Access Compliance Report

Public Rights-of-Way

(Curb Ramps)

Intersection ID: 52613	Main Street: GRAHAM RIDGE DR	Cross Street: HERITAGE POND DR	Location:	E
ADA ID: 2828AB278A2C	Ramp Type: Perp	Initial Pass/Fail: Fail	Overall Compliance: No	Severity Score: 12.5
Codes/Mitigation Info/Possible Solution		Field Measurements/Component Compliance

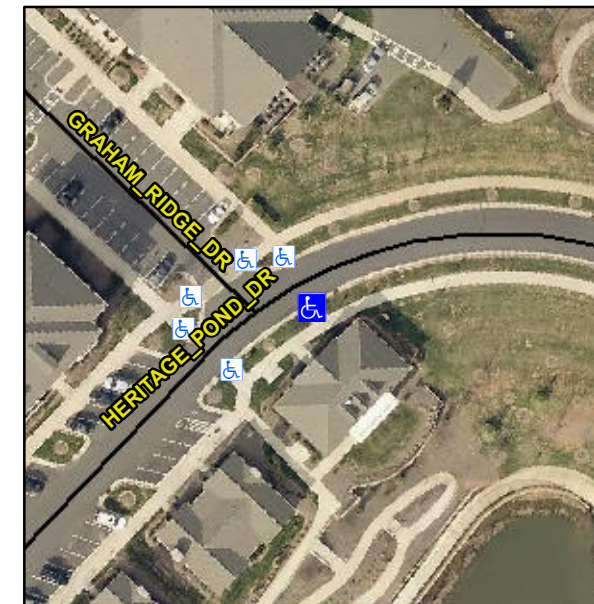
R304.2.2

Compliance	Description	Data	Compliance	Description	Data
N/A	Ramp Length (in)	97.0	No	Ramp Slope (%)	8.8
Yes	Ramp Width (in)	94.5	Yes	Ramp XSlope (%)	1.2
N/A	Flare Type LT	N/A	N/A	Flare Type RT	N/A
N/A	Flare Slope LT (%)	N/A	N/A	Flare Slope RT (%)	N/A
N/A	Flare Traversable LT?	N/A	N/A	Flare Traversable RT?	N/A
N/A	Landing Length (in)	N/A	N/A	DWS Provided?	N/A
N/A	Landing Width (in)	N/A	N/A	DWS Contrast?	N/A
N/A	Landing Slope (%)	N/A	N/A	DWS Length (in)	N/A
N/A	Landing X Slope (%)	N/A	N/A	DWS Full Width?	N/A
N/A	Landing Curb? (Y/N)	N/A	N/A	DWS Offset (in)	N/A
N/A	Shared Landing?	N/A			
N/A	Gutter Ponding?	N/A	N/A	Gutter Slope (%)	N/A
N/A	Gutter Lip Ht (in)	N/A	N/A	Gutter X Slope (%)	N/A
N/A	Painted X Walk1?	No	N/A	Painted X Walk2?	N/A
	X Walk 1 Direction	To NW		X Walk 2 Direction	N/A
N/A	X Walk 1 Width (in)	N/A	N/A	X Walk 2 Width (in)	N/A
	X Walk 1 Slope (%)	5.1		X Walk 2 Slope (%)	N/A
	X Walk 1 X Slope (%)	0.7		X Walk 2 X Slope (%)	N/A

Remove & Replace Entire Ramp.
